Reference: Response to Further Information Request 2 – SD21A.0159

Please find a response to Further Information Request (FIR) SD21A.0159 received from South Dublin County Council (SDCC) on the 18th November 2021.

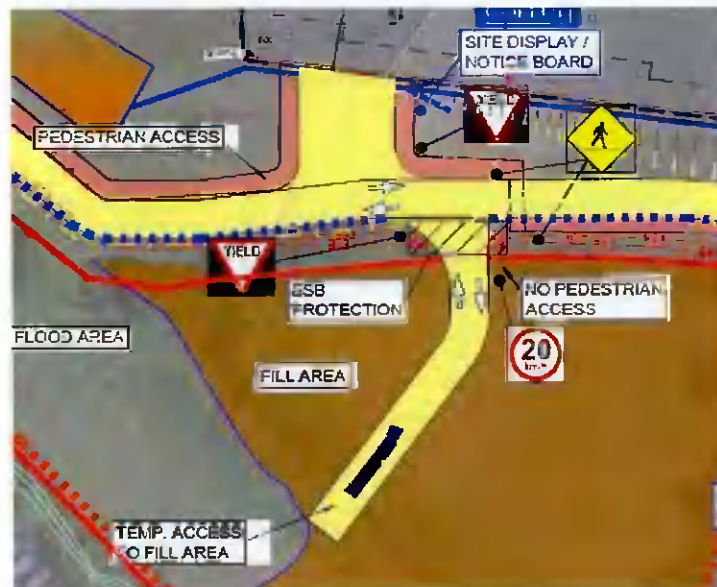
(B) (i) Readvertise the application and include the proposed removal of hedgerows and trees in the revised notices.

(ii) Provide layout drawings showing the proposed area for removal.

The proposed removal of hedgerow is approximately 6m wide. As part of granted planning application SD18A/0180 for the source site 'landscaping and fencing works' are granted. As the hedgerow to be removed is part the source site its removal is believed to be covered under this granted planning application.

The Site Layout Drawing no. J1387-CCL-10-SL-DR-001 submitted previously shows the hedging to be removed as hatched and as per site access road as per drawing snip below:
